DfT Reference: TWA/24/APP/03
Document Ref: CD26-01-APP-W5-2
The Cambourne to Cambridge Order

Inquiry into:
THE CAMBOURNE TO CAMBRIDGE ORDER

APPENDICES TO THE PROOF OF EVIDENCE
of
Chris Carolan
of WSP

Section	Page
APPENDIX A – GREATER CAMBRIDGE SHARED PLANNING (GCSP) – LVIA VIEWPOINTS.....	3
APPENDIX B – CAMBRIDGE PAST, PRESENT & FUTURE (CPPF) – LVIA VIEWPOINTS.....	5
APPENDIX C – NATIONAL TRUST – LVIA VIEWPOINTS	7
APPENDIX D – PAUL BRYAN – LANDSCAPE ADVICE/REVIEW	8

From: [Dinah Foley-Norman](#)
To: [REDACTED]
Cc: [REDACTED]
Subject: Cambourne to Cambridge (C2C) LVIA viewpoints
Date: 16 March 2022 15:38:21
Attachments: [Visual Assessment Plan Sheet 1 GCSP Markup.pdf](#)
[Visual Assessment Plan Sheet 2 GCSP Markup.pdf](#)

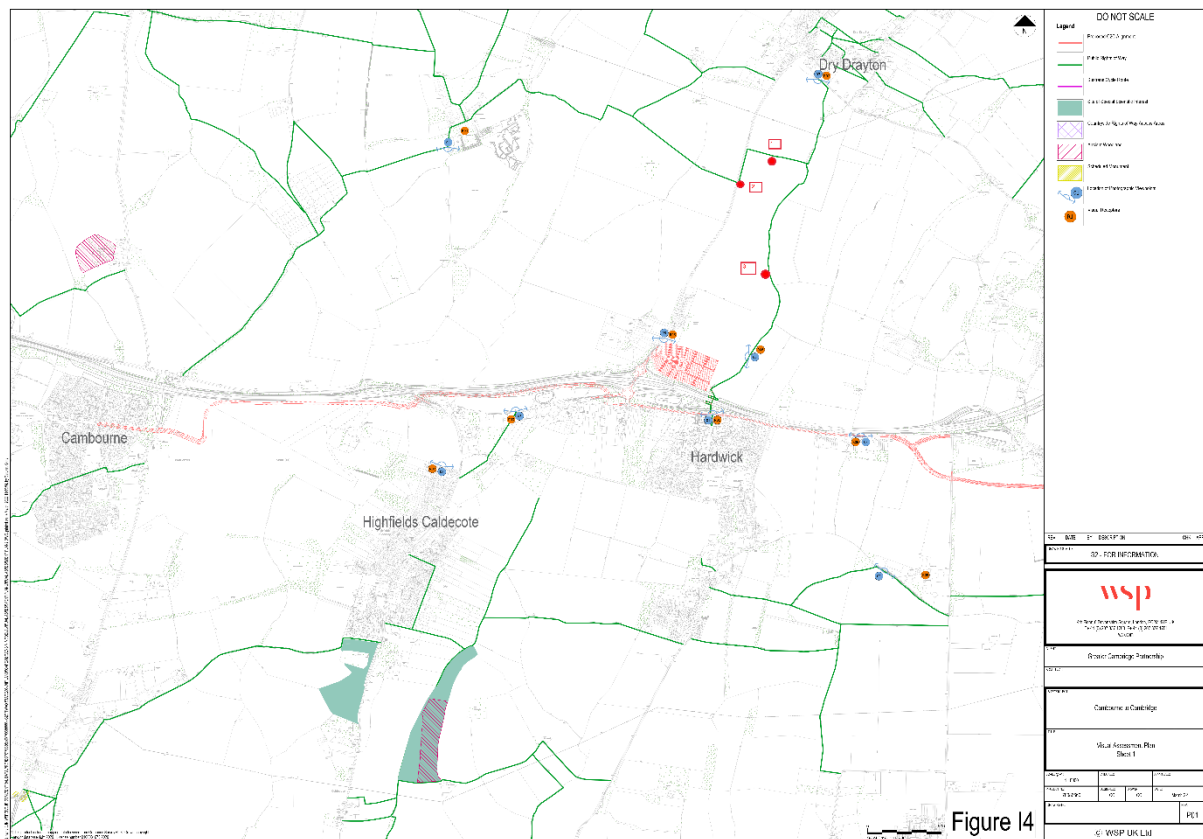
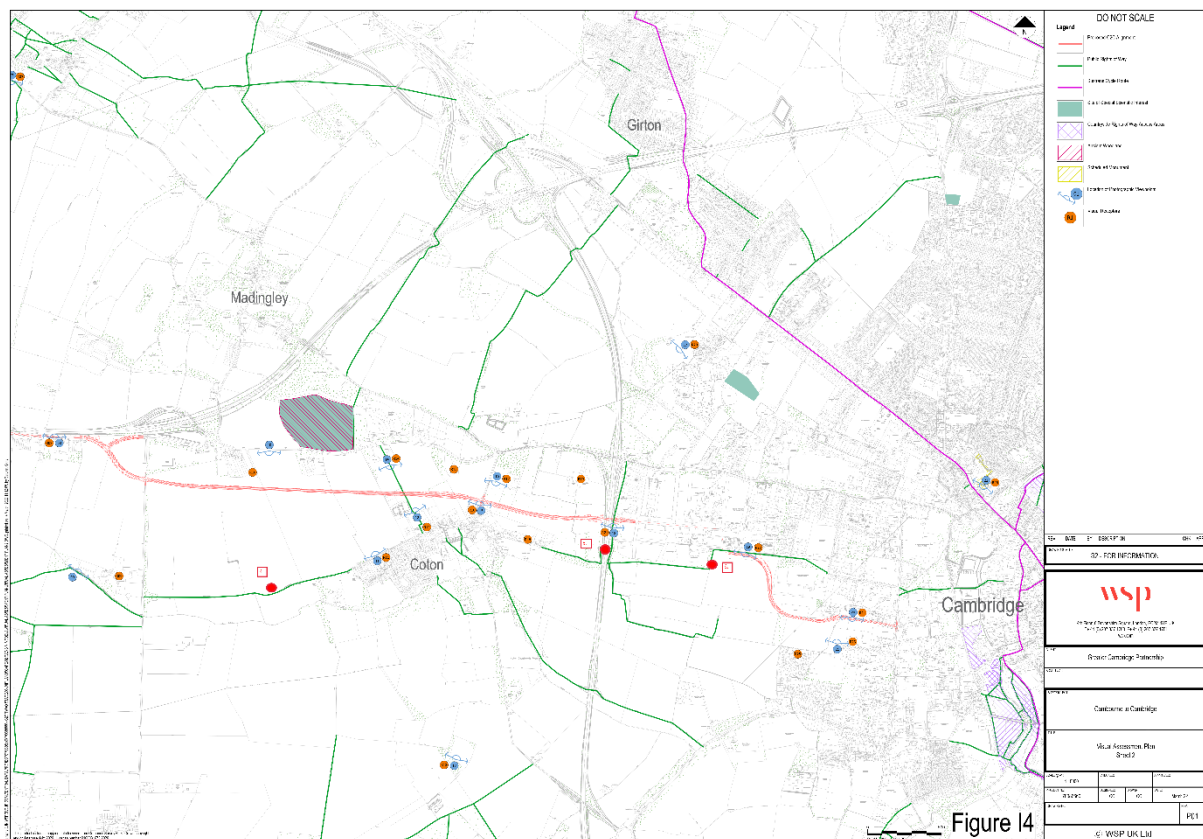
Hi All, Thanks for taking us through the C2C route and explaining some of the nuances to us. I have attached a marked up pdf with six additional viewpoints we believe need testing shown in red.

Can you confirm if you will be including views during the hours of darkness - we believe we will need them particularly for the park and ride which sits on high ground.

It would be useful if you could let us have the viewpoints on a base that include contours so that it is clear where the highpoints lay.
